**WHITE LAKE TOWNSHIP
ZONING BOARD OF APPEALS**

**REPORT OF THE
COMMUNITY DEVELOPMENT DEPARTMENT**

Agenda item: 8d

RE: Gateway Crossing
Preliminary Site Plan and Special Land Uses – Review #4

SHEET NO:
PP-5

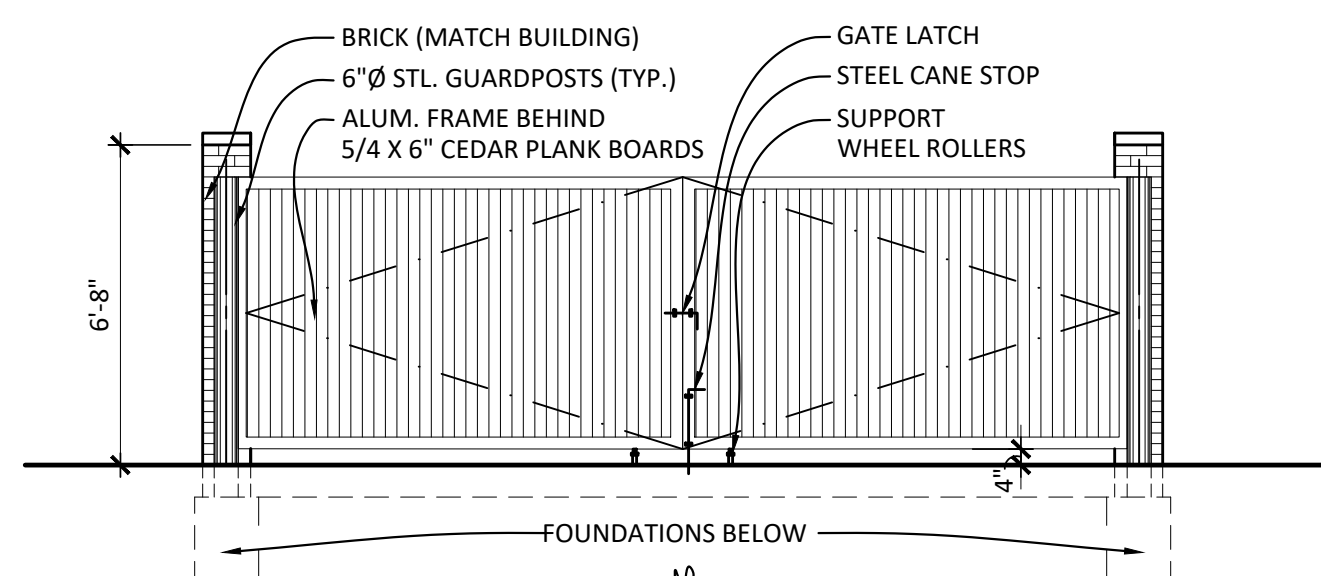
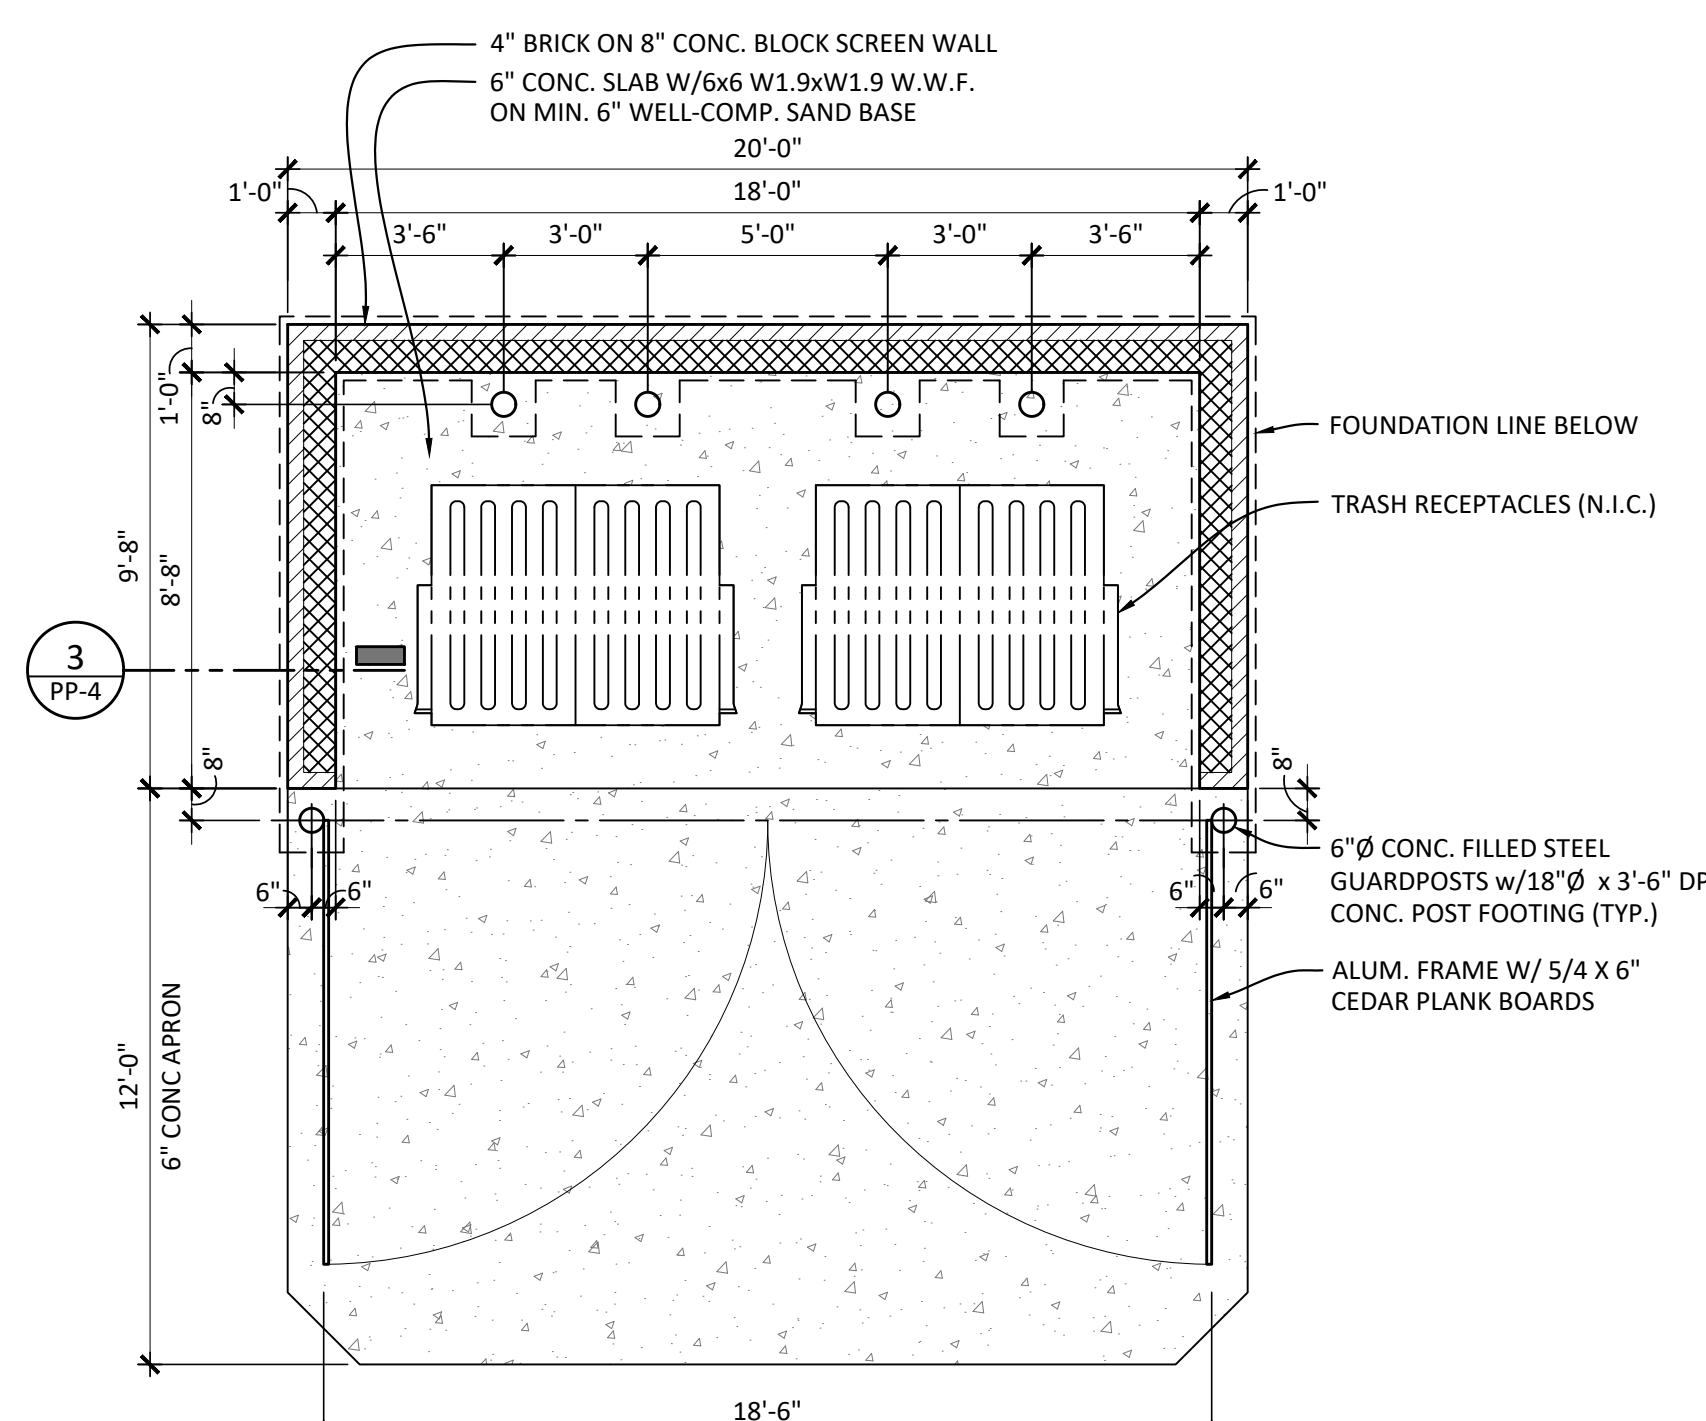
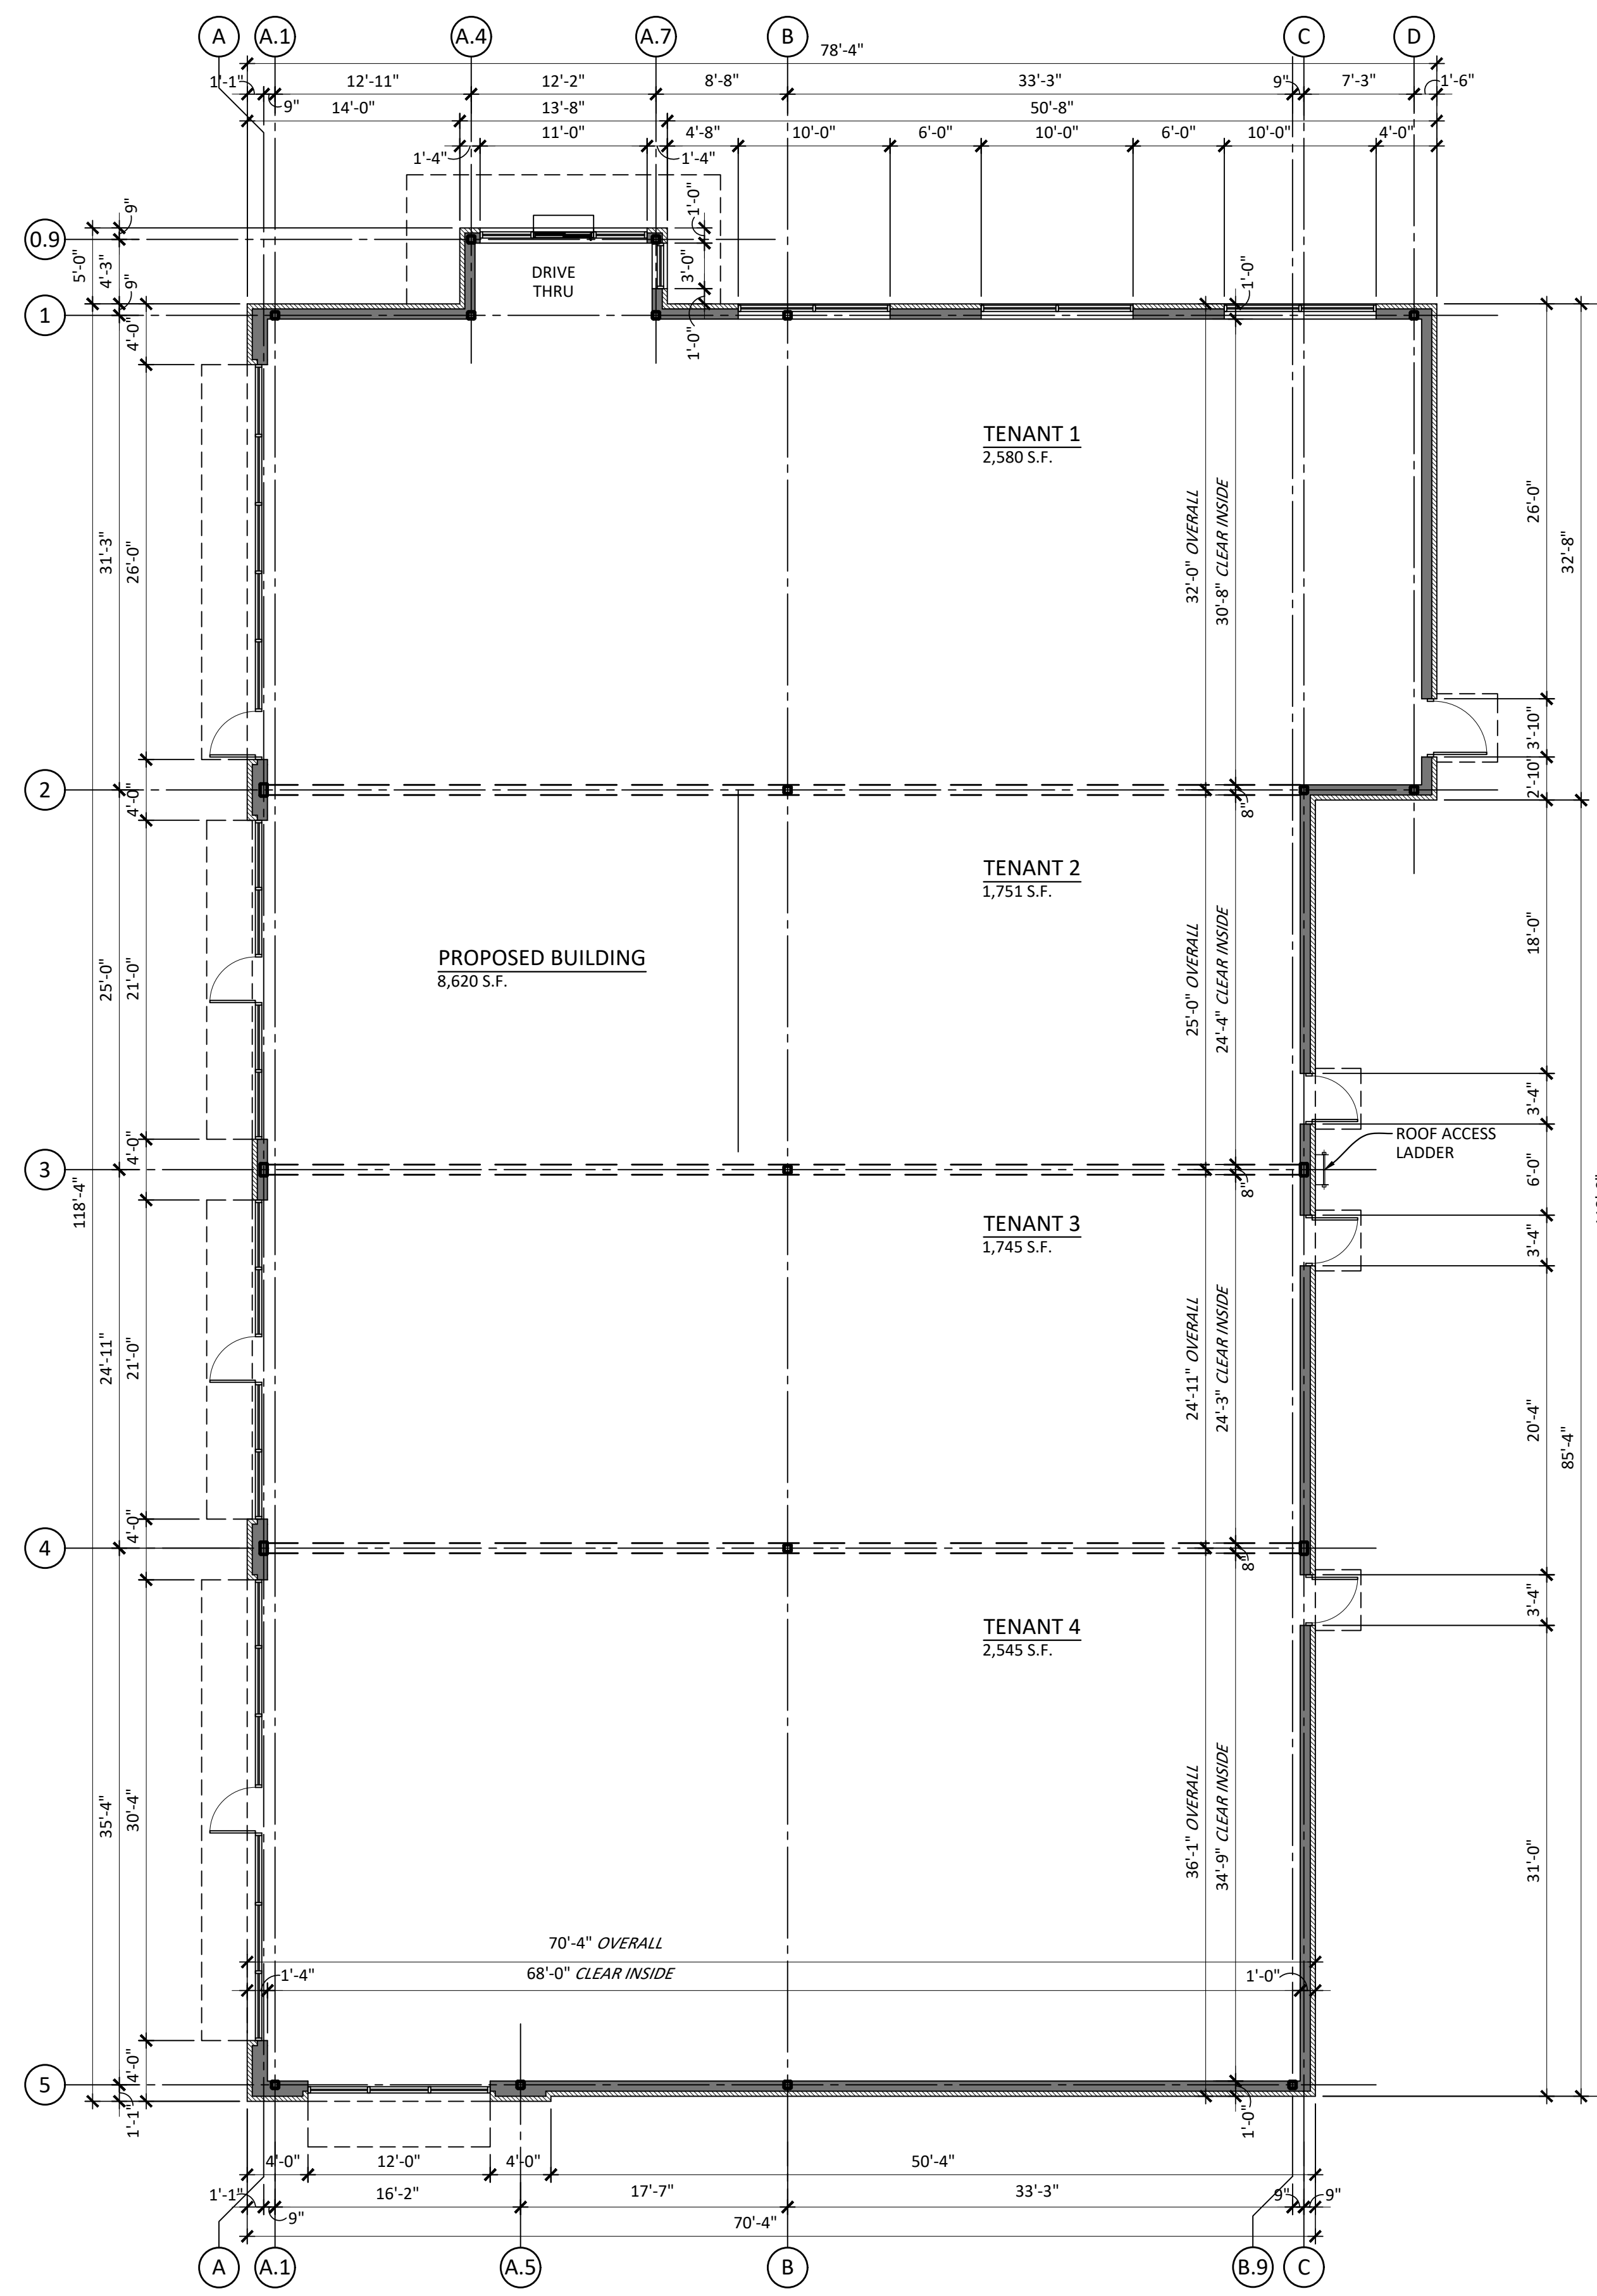
The zoning ordinance requires dumpsters to be surrounded by a six-foot-tall wall on three sides and an obscuring wood gate on a steel frame on the fourth side, located on a six-inch concrete pad extending 10 feet in front of the gate, with six-inch concrete-filled steel bollards to protect the rear wall and gates. Furthermore, the zoning ordinance states dumpsters and trash storage enclosures shall be constructed of the same decorative masonry materials as the buildings to which they are accessory. Brickform concrete (simulated brick pattern) or stained, decorative CMU block are not permitted where the principal building contains masonry. Plain CMU block is also prohibited. A dumpster enclosure detail was provided on Sheet PP-1. **(The aforementioned sheet has been renumbered as PP-3 with the second submittal).** **(The aforementioned sheet has been renumbered as PP-4 with the third submittal).** **(The aforementioned sheet has been renumbered as PP-5 with the third submittal).**

At the time of trash pick-up, the location of the dumpster enclosure could cause conflict with traffic entering and exiting the site. The dumpster enclosure location should be evaluated when considering circulation around the site. (Comment addressed. One dumpster enclosure has been eliminated and the other dumpster enclosure location has been revised to reduce conflict with traffic).
